HISTORIC LANDMARK COMMISSION
Applications for Permits in National Register Historic Districts
February 4, 2026
HR-2026-004703
Old West Austin Historic District
702 Winflo Drive

Construct a new residence at a property with a previously approved demolition.

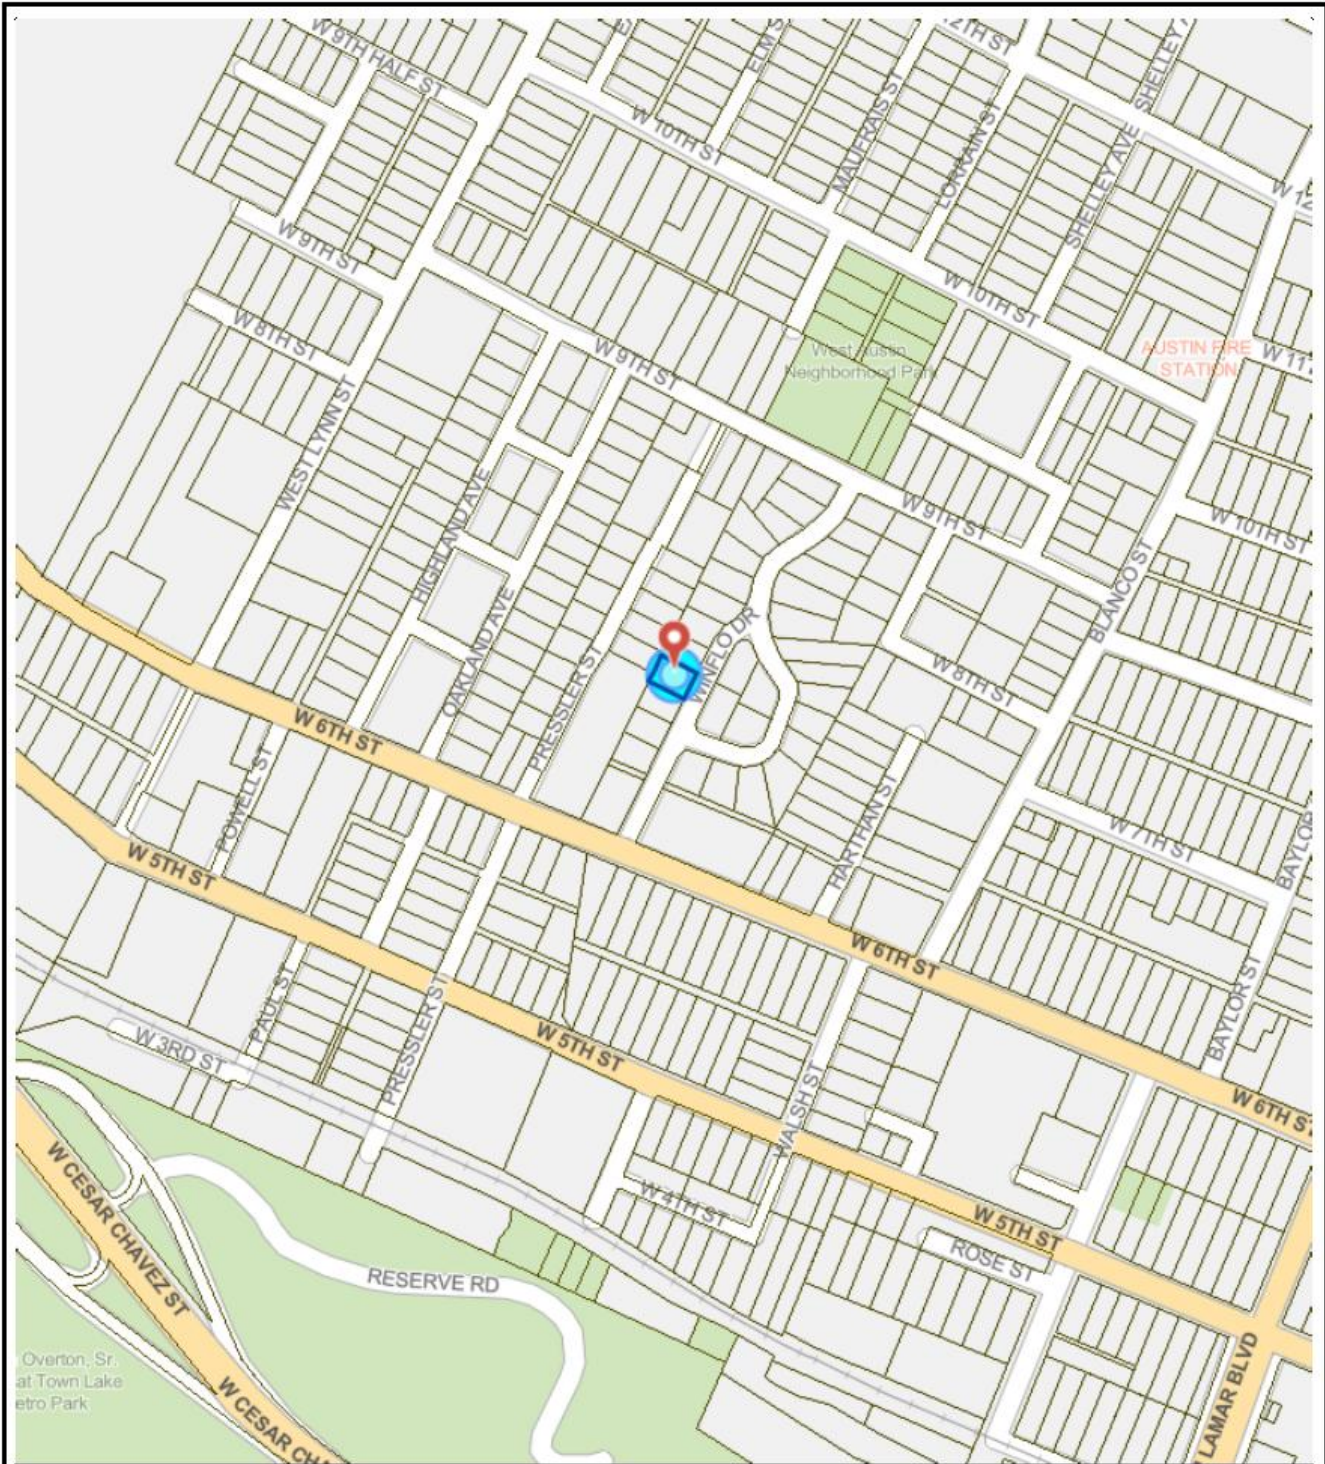
Proposed design reads as a single-family house, similar to the majority of the district. However, the inclusion of a second story raises the overall height to around 28 feet. While there are other examples of contributing properties that are two stories, they are uncommon. The overall width of the house is in keeping with neighboring properties.

Proposed design is distinct from any historic form in the district. The modern design does not create a false sense of historicism, nor does it borrow from any historic styles that appear out of place. Though the design reads as different from neighboring contributing properties, it does not overwhelm the streetscape and meets Standard 5.3.

A flat roof is proposed, which is distinct from its direct neighbors. However, there are contributing properties to the district that make use of flat roofs, making this proposal not entirely out of place.

Proposed exterior walls are to be clad in brick and stucco. Both of these materials are found in the district, and will not overwhelm or distract from the surrounding streetscape.

Window patterns do not match with nearby contributing properties, with most fenestration placed at corners and not at centers of exterior walls. Window sizes are generally appropriate, and design elements such as simulated divided lites or false muntin/mullions are avoided. The front door faces the street as recommended by the Design Standards.

Attached garage is at the front of the building and housed within the overall building mass. Like this design, numerous contributing properties do have curb cuts with garages facing the street at an equal setback with the house, but these are typically to the side or as an extension to the house, not underneath a second floor, as is proposed here.

January 14, 2026: Scale, material, and overall volume of proposed design are appropriate, but look to other contributing properties in the neighborhood to more align with design elements such as a front porch or stoop, exterior cladding, or roof forms. Consider redesign of the fenestration patterns on the front elevation to make the spacing more in keeping with windows at nearby contributing properties.
